City of Florence Planning Commission Meeting 250 Hwy 101, Florence, OR 97439 November 26, 2019

4. RESOLUTION PC 19 22 PUD 03 – DevNW Preliminary Planned Unit Development (PUD)

DevNW Airport Road

Preliminary Planned Unit Development (PUD), Tentative Subdivision Plan Review (SUB), and Conditional Use Permit (CUP) for proposed development of 12 affordable, single-family, detached dwellings.

Street Widths

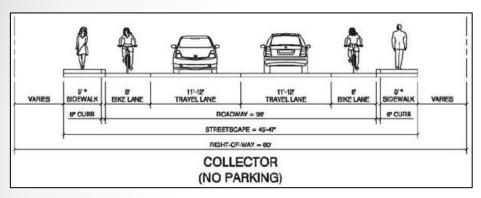
<u>Issue 1</u>: The paved roadway section of 15th Street is 33 feet and 10 inches at the subject property. The nexus for a half street improvement, widening this section of 15th Street to either 36 feet (Collector, No Parking) or 38 feet (either Collector, On Street Parking or Collector, On-Street Parking), is present (FCC 10-36-2-5). In addition, Phase A of the PUD (Keener Place) was required to install a parking strip pull-out along their section of the 15th Street frontage; as such, there is an issue of proportionality present.

- (1) the applicant will enter into a non-remonstrance agreement, consenting to financial participation and granting of easements as needed for future improvements to the section of 15th Street adjacent to DevNW Airport Road,
- (2) the applicant will complete a half-street improvement of the same section of 15th Street, widening it 2 feet 2 inches (to meet the criteria of a Collector, No Parking), or
- (3) the applicant shall complete a half-street improvement of the same section of 15th Street, widening 4 feet 2 inches and installing a parking strip pullout (to meet the criteria of Collector, On Street Parking).

Testimony

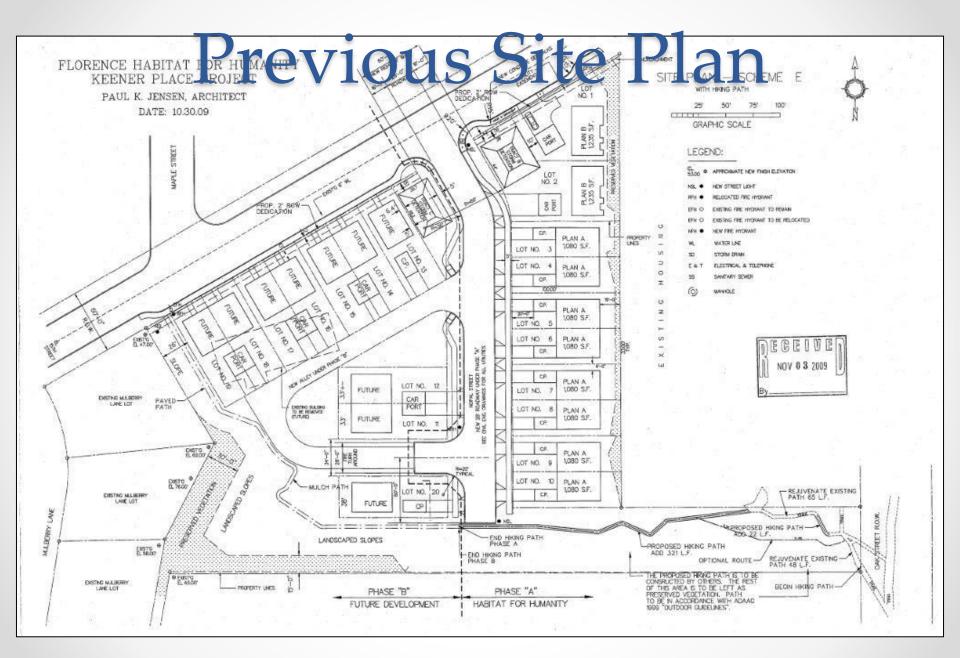
Mr. Hornung's property is located on the west side of the vegetated slope the applicant proposes to clear and grade. Mr. Hornung expressed the following concerns in his testimony:

- (1) The foundation of his property may be destabilized by the proposed grading and vegetation removal;
- (2) large trees on Mr. Hornung's property may be destabilized by the proposed grading and vegetation removal;

- (3) the original plans for Phase B included a buffer adjacent to his property line, which is not in the current plans (the condition reads, in part, "The western property line will have a least a 16-foot buffer for the corner lot of Mulberry Lane and 15th Street and the remaining lots of Mulberry subdivision will be adjacent to Phase B open space.");

- (4) the applicant is proposing removal of native vegetation (specifically Rhododendrons), which is in contradiction with the City of Florence Municipal Code and the Comprehensive Plan, which include protections for native vegetation and Rhododendrons;

- (5) the proposed removal of vegetation may displace the animals which inhabit it;
- (6) the parking areas proposed are adjacent to the low-density residential zone; and

- (7) FCC 10-23-5-C states, "The Planning Commission may require a yard at least as deep as that required by the front yard regulations of the district adjacent to the PUD on any, or all, sides of the PUD." The front yard setback in the Restricted Residential district is 20-feet.
